SHEET TITLE:
BLOCK GRADING PLAN (SOUTH WEST)

CLIENT:
**FICKLING AND CO.
MACON, GA**

PROJECT:
**LULLWATER AT FORT
CLARKE BLVD**

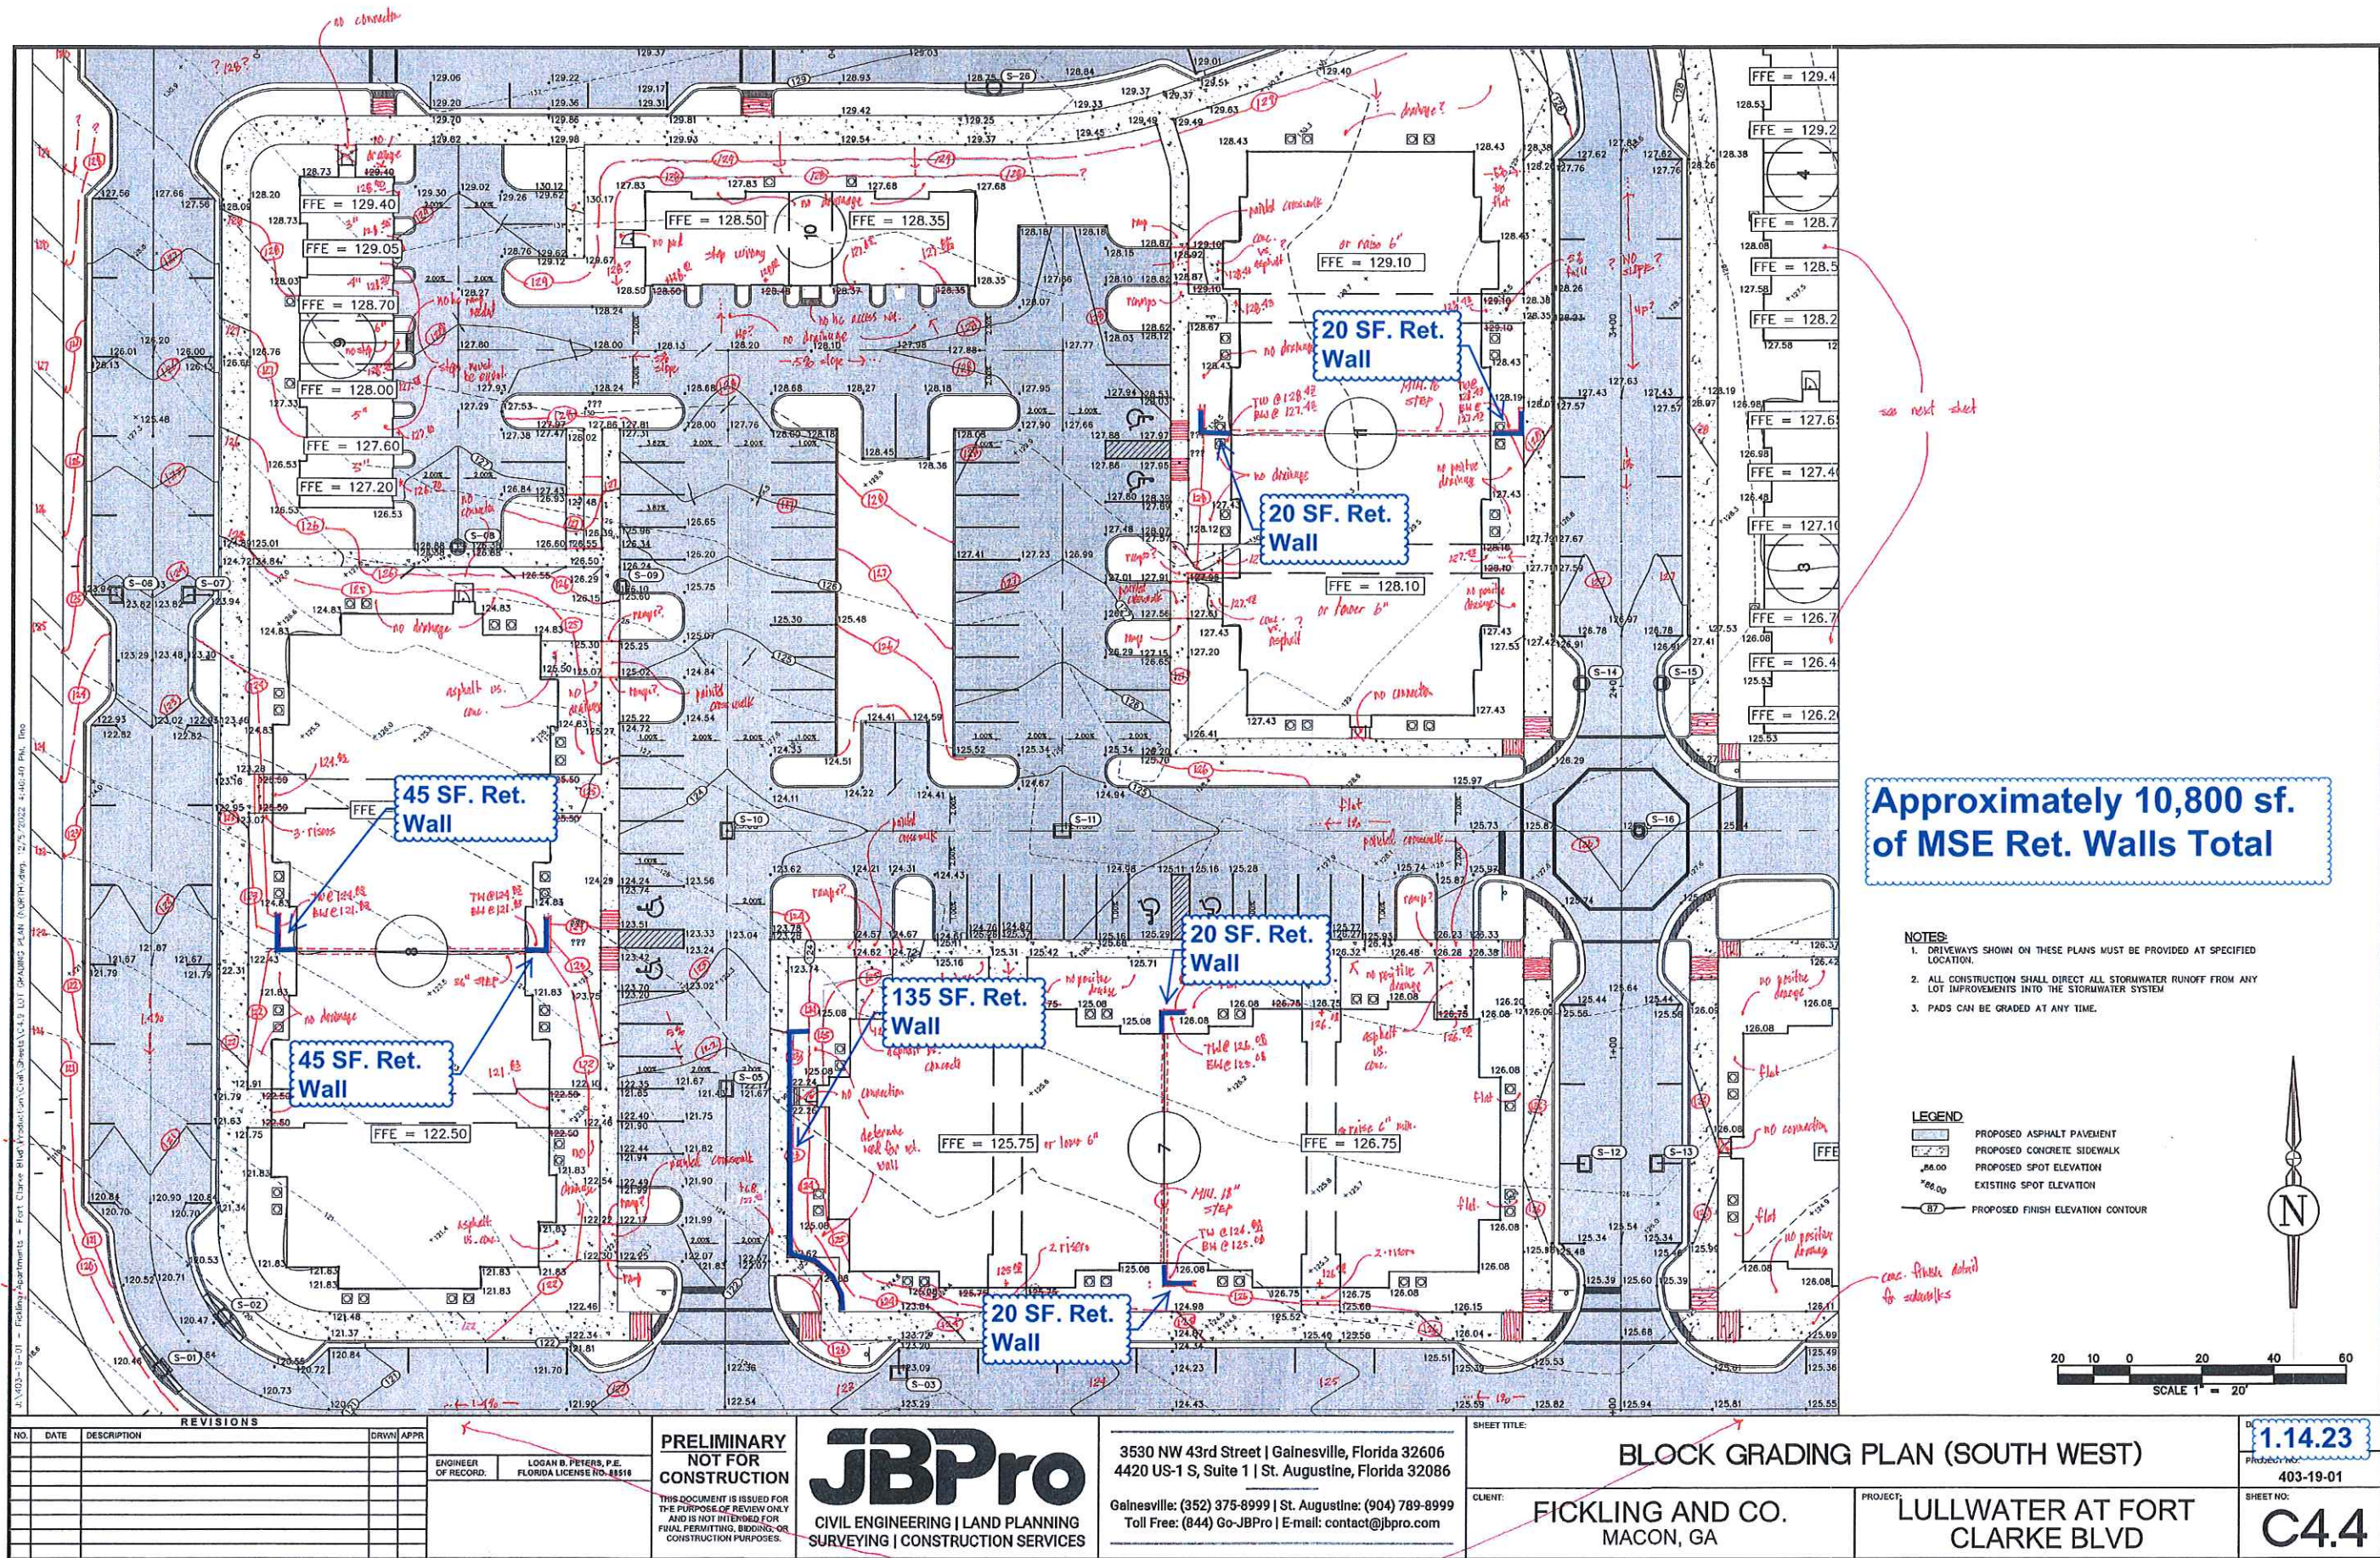
Approximately 10,800 sf. of MSE Ret. Walls Total

BLOCK GRADING PLAN (SOUTH EAST)

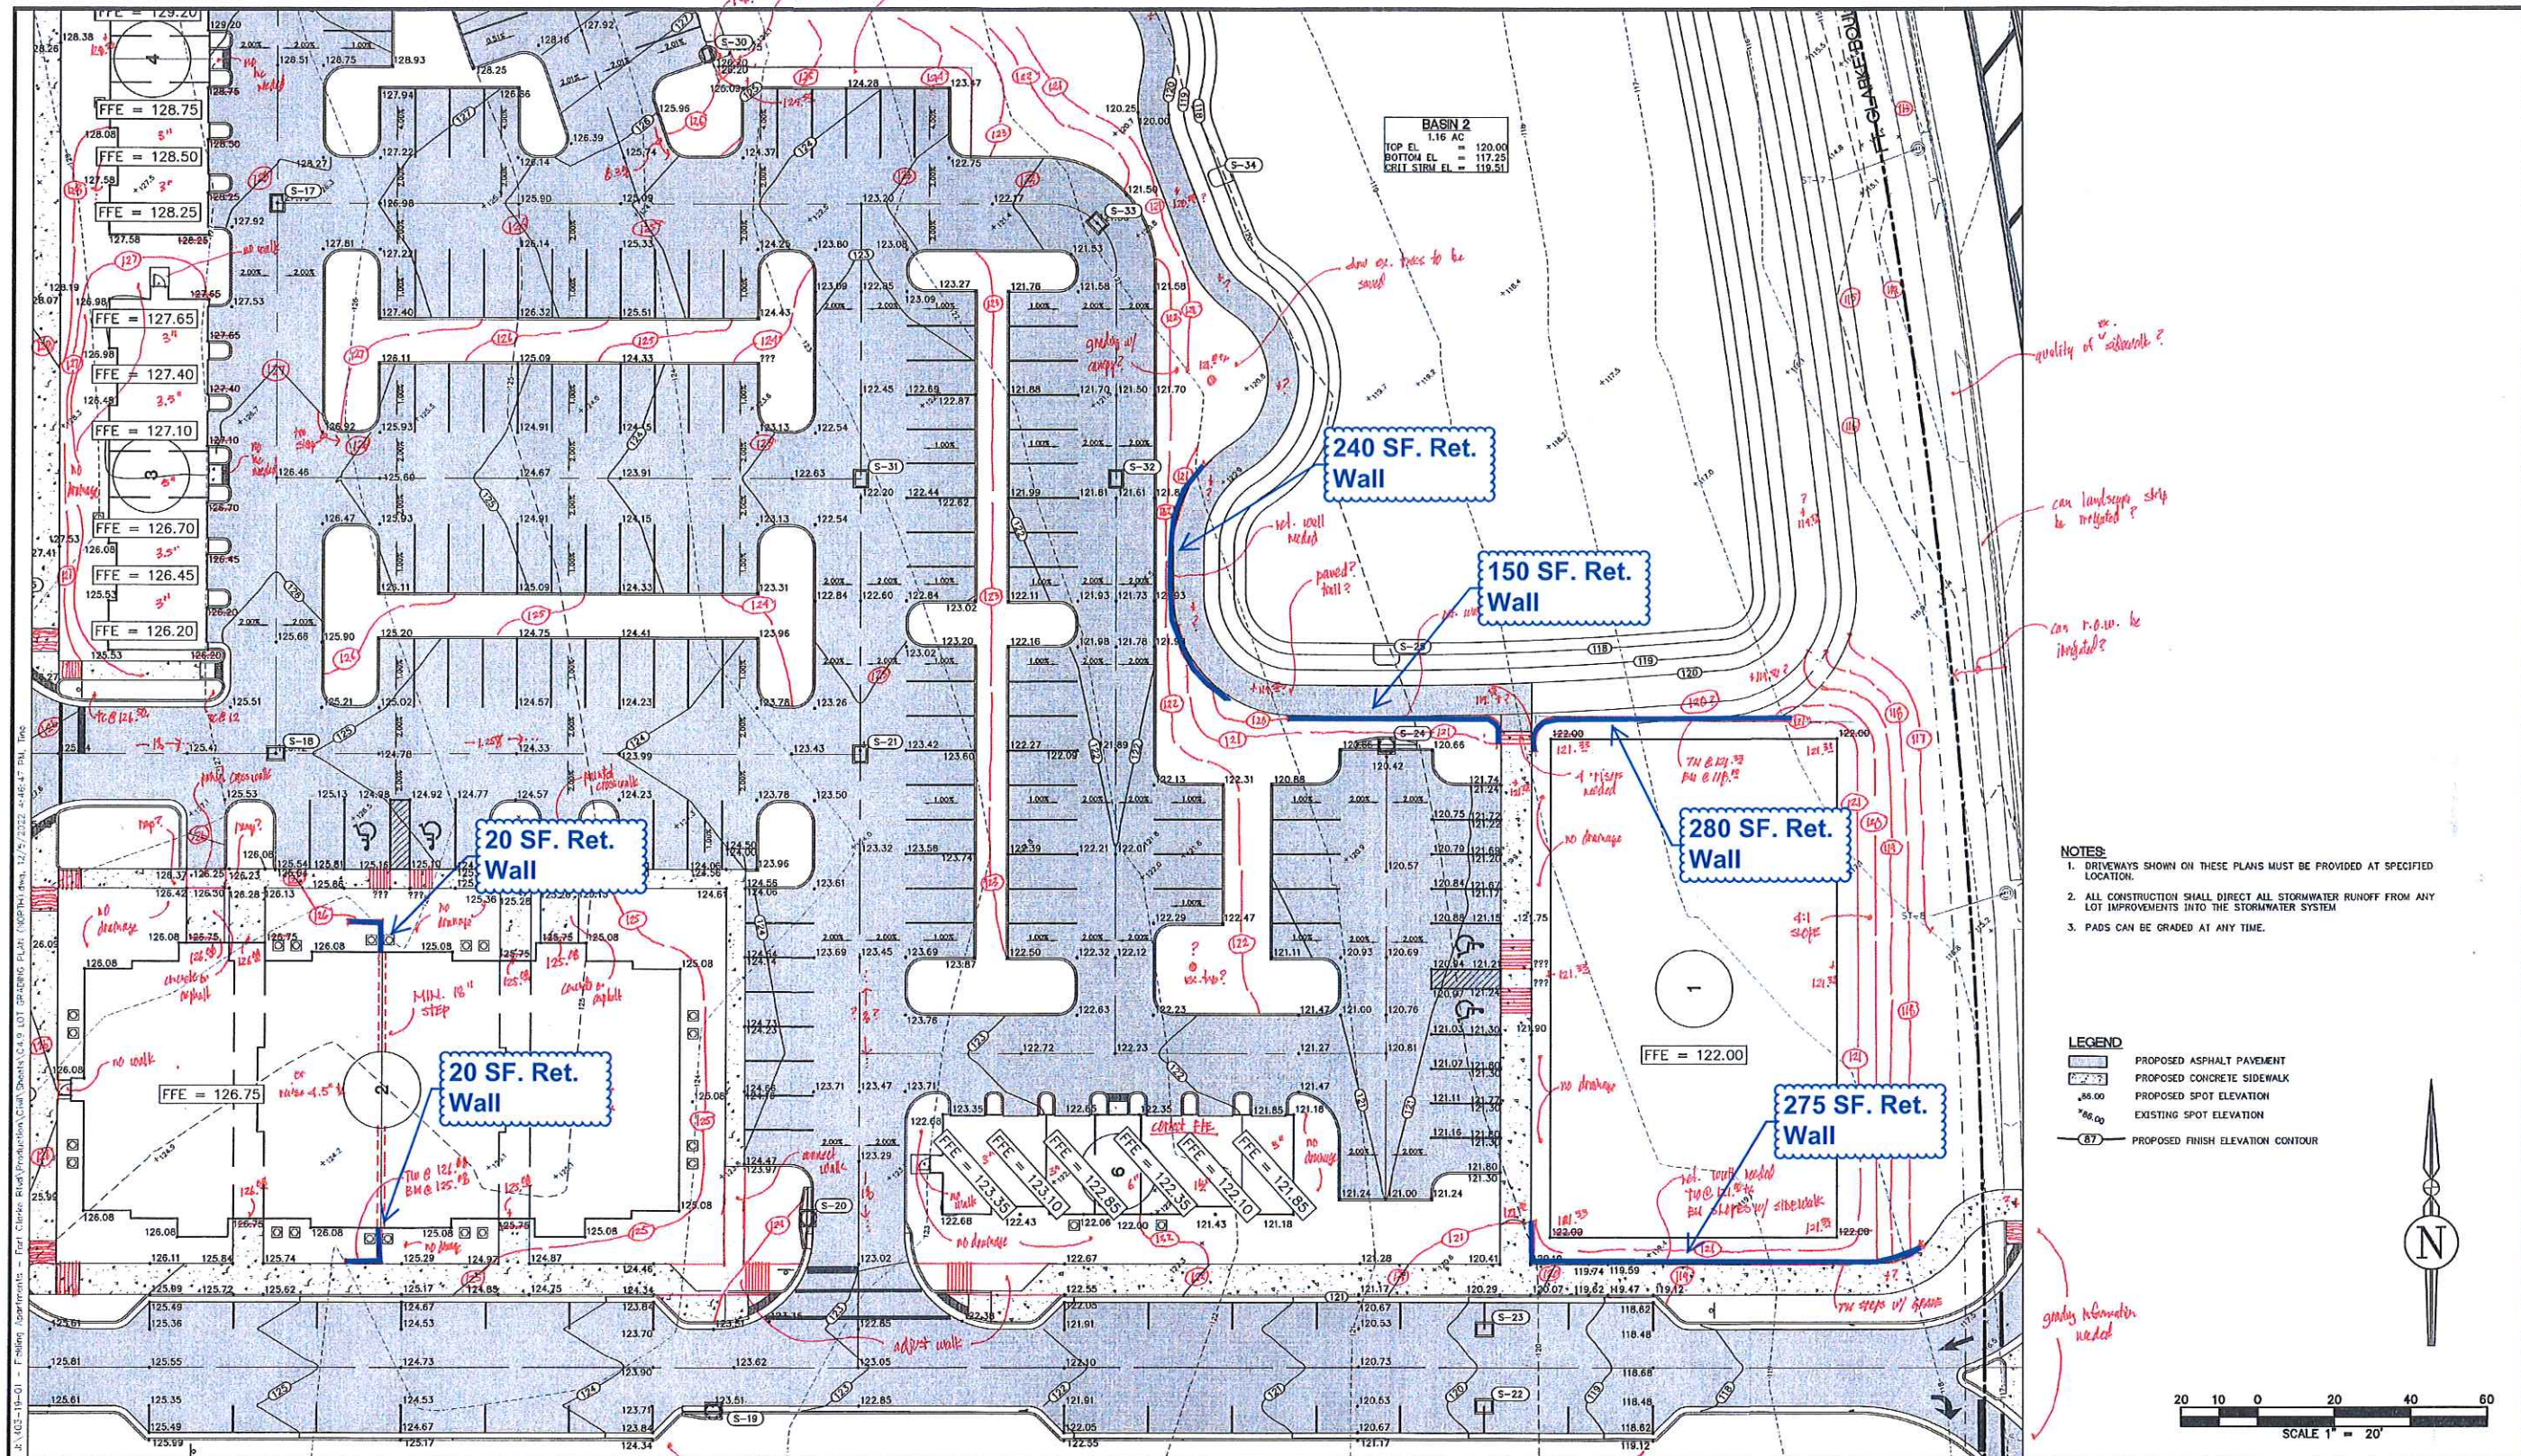
Ret. Walls may be required along buffer. Not determined at this time.

Ret. Walls may be required along buffer. Not determined at this time.

SHEET TITLE:
BLOCK GRADING PLAN (CENTRAL WEST)

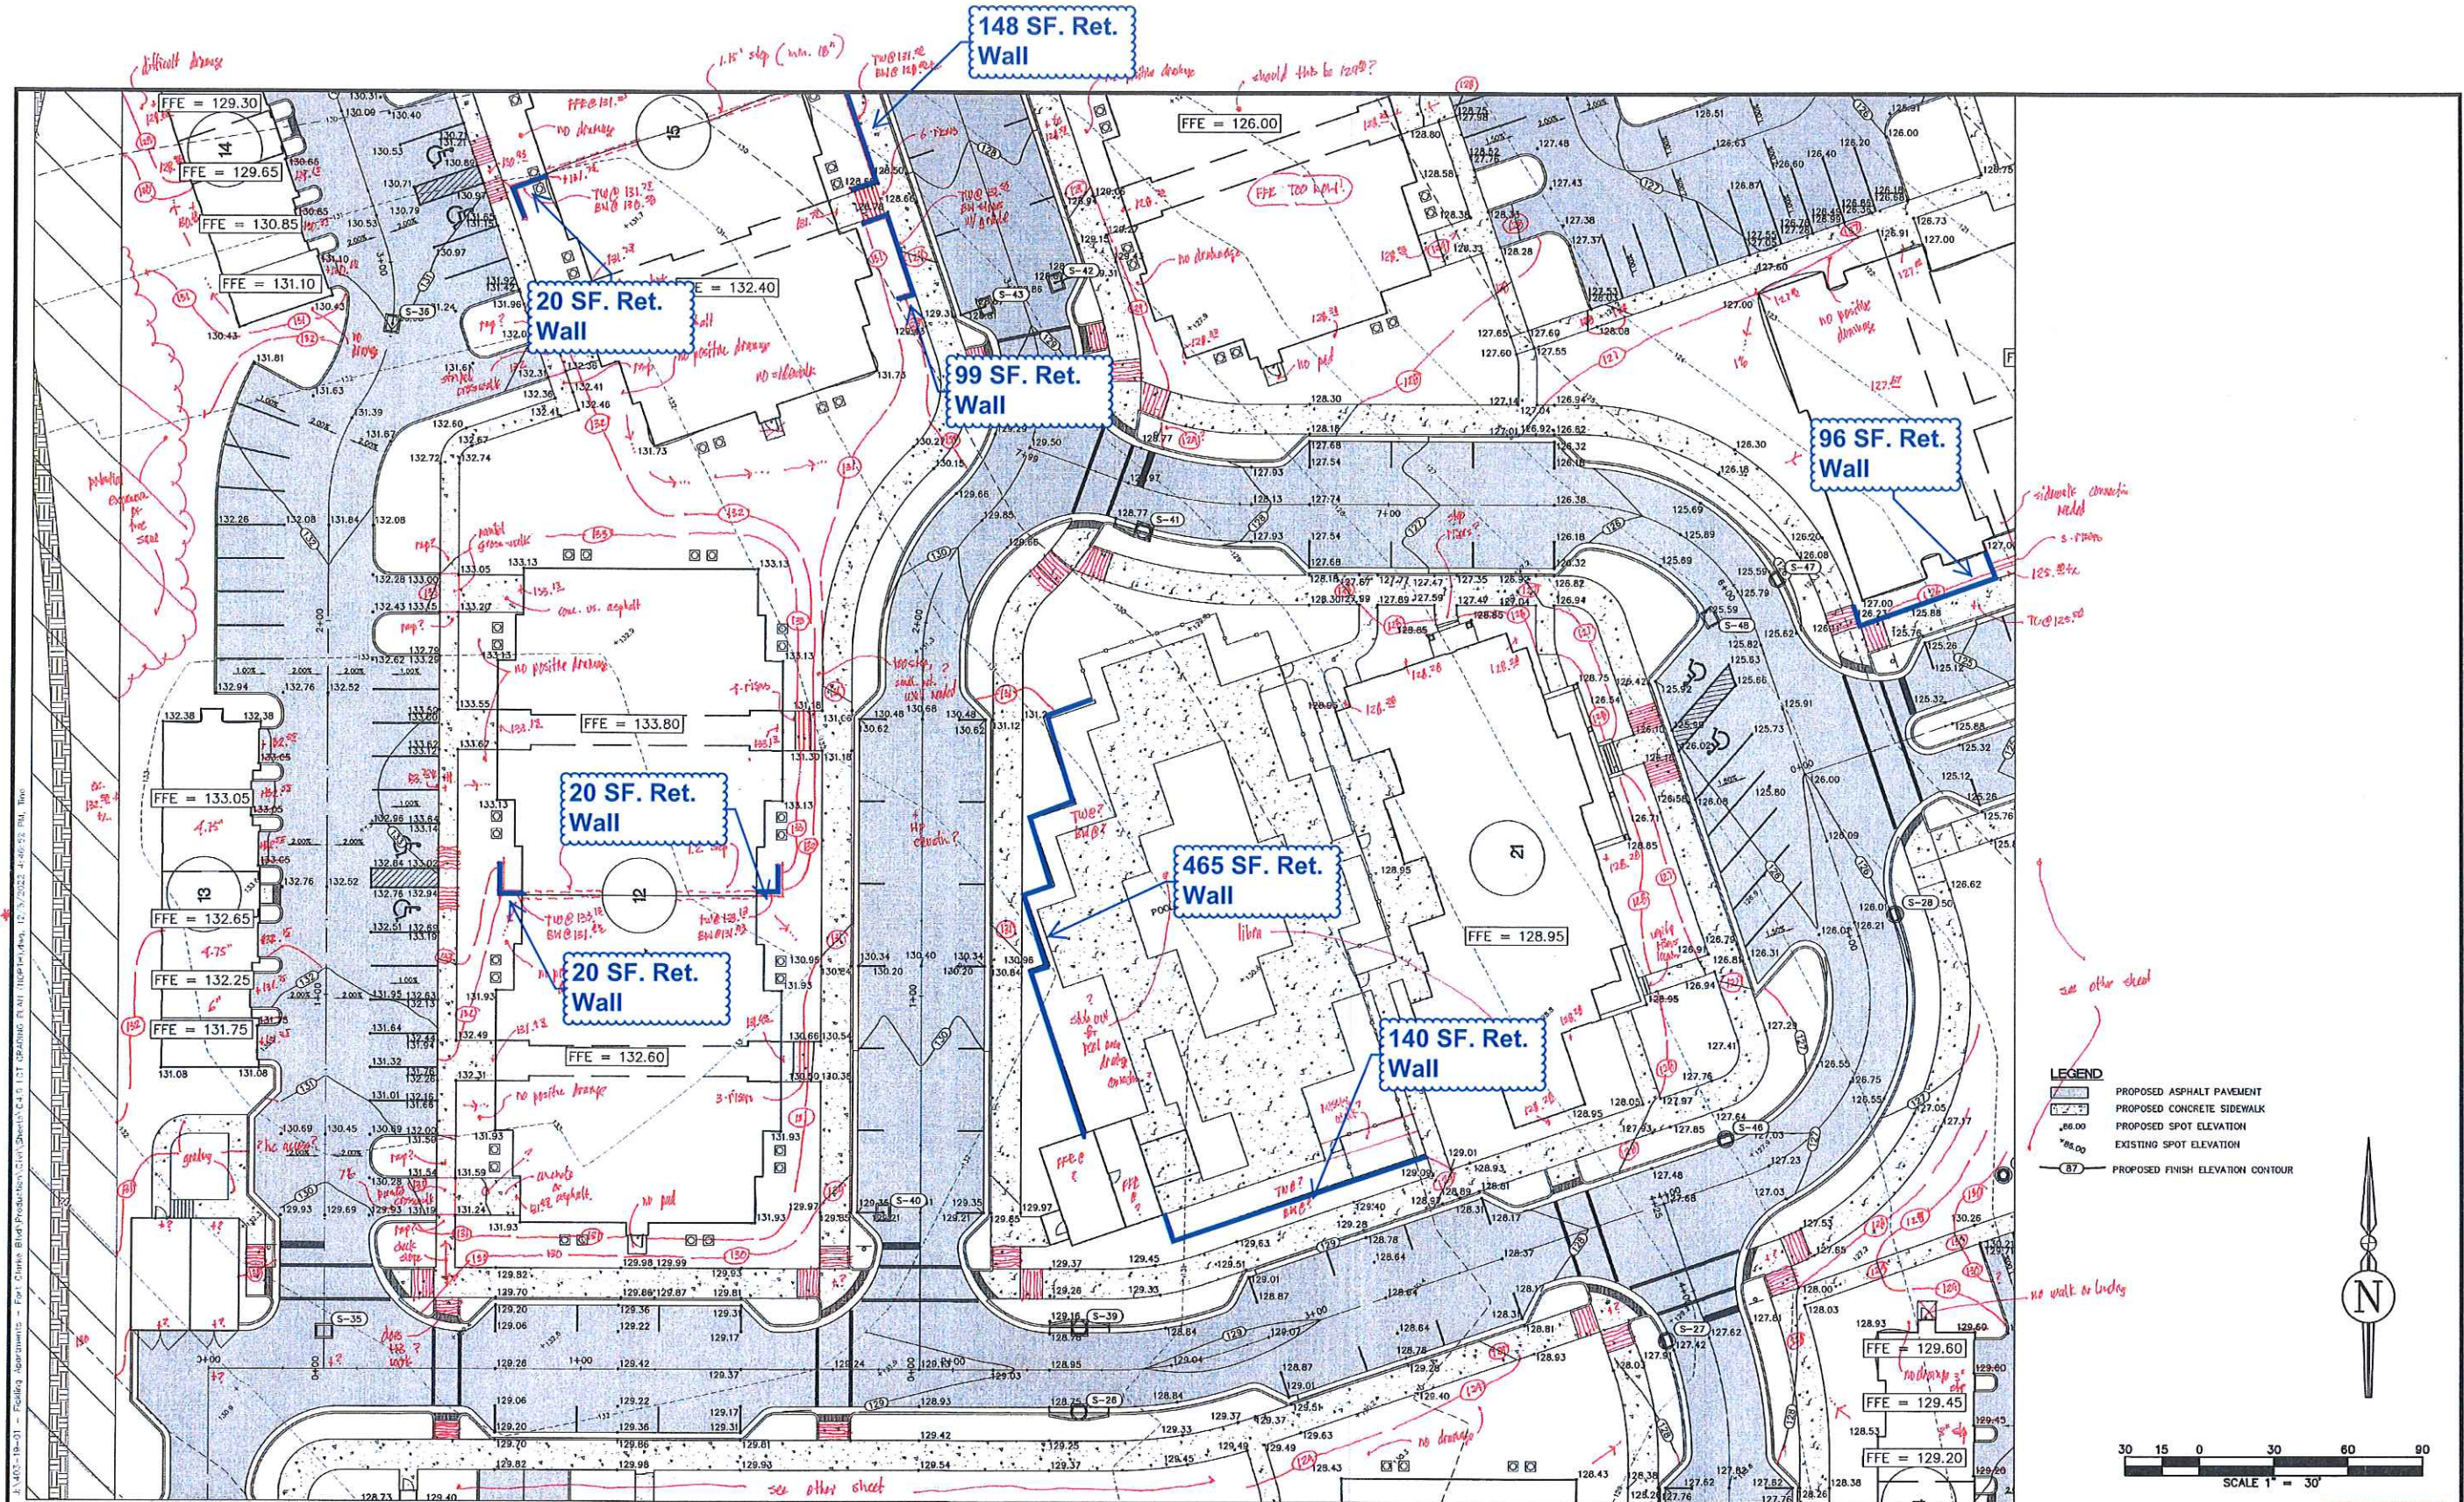
no grading shown @ tree zone/buffer
